Technical Response to the Representation Submitted by Llanbedr and Pensarn Yacht Club in Relation to Marine Licence Application DML2622

Date: 22 September 2026
Project name: Shell Island 2026
Company: Jacobs
Prepared by: Nigel Pontee

Figure 1. Examples of contrasting Bar Newydd configurations illustrating periods when the bar is extended to the north east (2016) and periods when the bar is breached offering a shorter navigation route to the sea (2026).

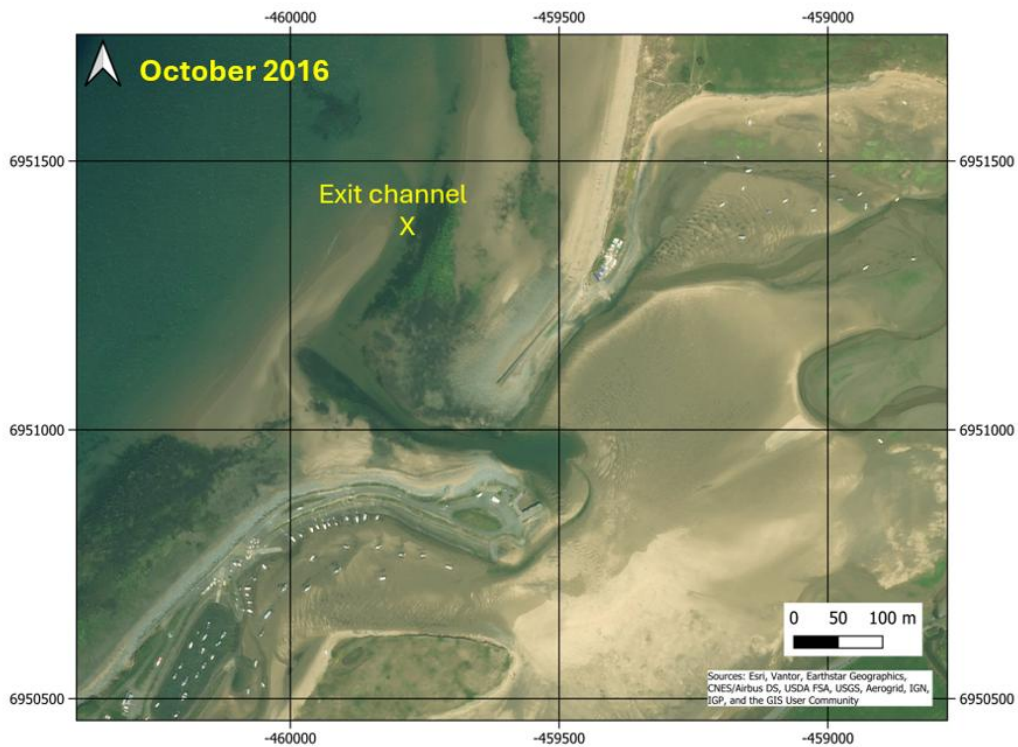
LPYC state that following the 2013/14 maintenance dredging campaign, completed by February 2014, sediment deposited on Bar Newydd remained on the bar for approximately six months, causing shoaling and affecting navigation. LPYC report that vessels entering and leaving the estuary were required to alter their approach route and navigate closer to the beach to avoid swell breaking over the shoaled bar.

The observations reported by LPYC are acknowledged. However, no bathymetric surveys, navigation records, hydrographic surveys or other quantitative evidence have been provided to demonstrate the magnitude of the reported shoaling, the duration of any change, or the extent to which conditions differed from the normal variability of Bar Newydd.

Historical aerial imagery also demonstrates that Bar Newydd undergoes substantial natural changes in morphology over time. Comparison of aerial photographs shows periods when the bar extends significantly towards the north-east (e.g., October, 2016) and periods when it is breached and considerably shorter (e.g., March, 2026). These observations are consistent with Richard Workman's description of recurring cycles of extension, breaching and reformation and demonstrate that substantial changes in bar morphology occur naturally, independent of dredging activity (Figure 1).

Figure 2. Approved disposal area at Bar Newydd and approximate area of alleged sediment accumulation referred to within the LPYC representation.

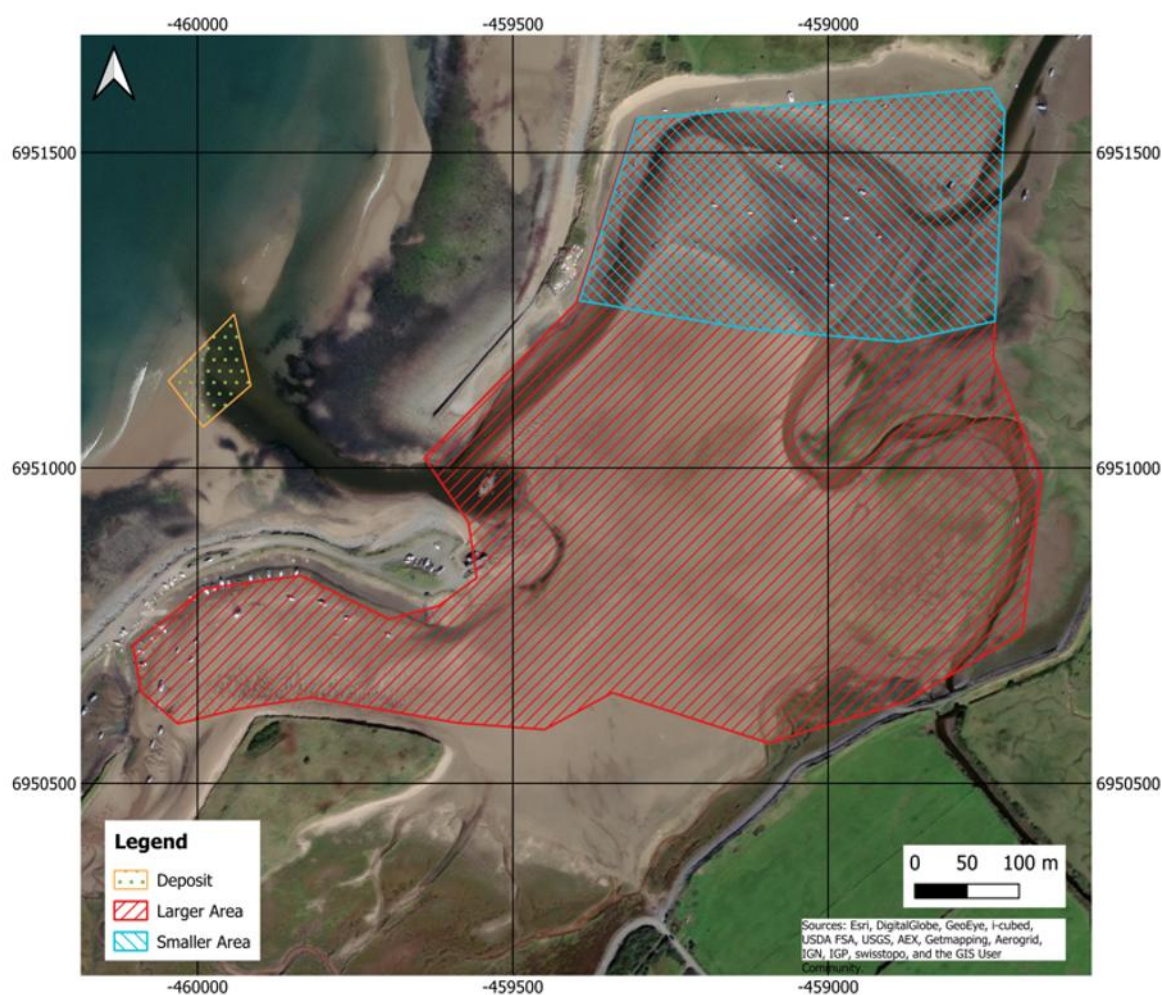
LPYC state that sediment placed on Bar Newydd during the 2013/14 dredging campaign did not migrate northwards as predicted but was instead transported back into Mochras Lagoon, affecting moorings within the estuary. LPYC further suggest that a similar process may have occurred following the 2020 dredging campaign.

Even if sediment accumulation occurred in the area identified by LPYC, it is difficult to demonstrate that the sediment originated from Bar Newydd, and the volume involved would be relatively small when distributed over the areas concerned. Figure 2 shows the approved disposal area together with the broad area within which LPYC allege sediment accumulation may have occurred (the smaller blue hatched area). The figure illustrates the spatial separation between the disposal area and the mooring areas referred to in the representation, together with the complexity of the potential sediment pathways between the two locations.

The quantities of sediment involved should also be considered in context. Assuming a dredged quantity of approximately 4,000 tonnes and a bulk wet sediment density of approximately 2.0 t/m^3 , the disposed volume would be approximately $2,000 \text{ m}^3$. If this entire volume were distributed across the broader area of Mochras Lagoon identified by Jacobs as potentially influenced by sediment redistribution (approximately $307,000 \text{ m}^2$), the equivalent average increase in bed level would be approximately 7 mm. Even if the material were assumed to accumulate solely within the smaller area corresponding approximately to the LPYC mooring area where increased siltation has been alleged (approximately $80,000 \text{ m}^2$), the equivalent average increase in bed level would be approximately 3 cm. Whilst these calculations are highly simplified and do not represent actual sediment behaviour, they illustrate both the relatively small average thicknesses involved and the difficulty of inferring sediment provenance from observed changes in bed levels alone.

Figure 3. Principal sediment pathways identified within previous studies and assessments.

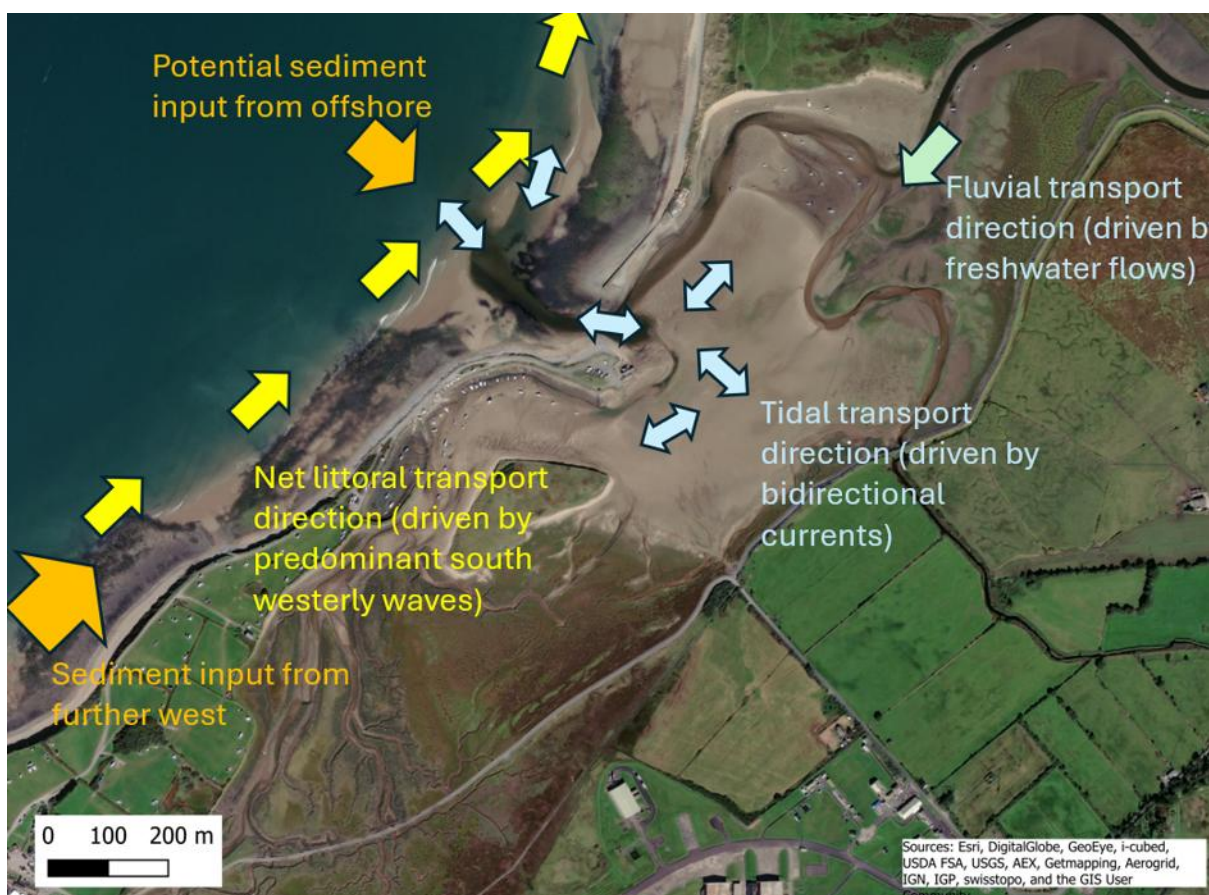
LPYC argue that the current application relies upon an assumption that sediment disposed at Bar Newydd will be transported northwards along the coast. LPYC contend that observations following the 2013/14 and 2020 disposal operations do not support this prediction and suggest that sediment may instead remain within the vicinity of the disposal site and subsequently return to the estuary. LPYC further note that the favourable conclusions presented within the Environmental Report, Habitats Regulations Assessment (HRA) and Water Framework Directive (WFD) assessment rely upon this sediment-transport assumption being correct.

Figure 3 illustrates the principal sediment pathways identified within previous studies and assessments, including northward littoral transport along the Morfa Dyffryn frontage and sediment exchange between the estuary and adjacent coast.

Importantly, the existence of a net northerly transport pathway does not imply that all sediment placed on Bar Newydd will move northwards, nor that movement will occur at a constant rate. Longshore sediment transport describes the net movement of sediment within the coastal system over time. Individual sediment deposits may be temporarily reworked, redistributed or stored within bars, beaches and shoals before becoming incorporated into the wider transport system. Consequently, short-term observations following a particular disposal campaign do not necessarily provide a reliable basis for evaluating longer-term coastal sediment transport patterns.
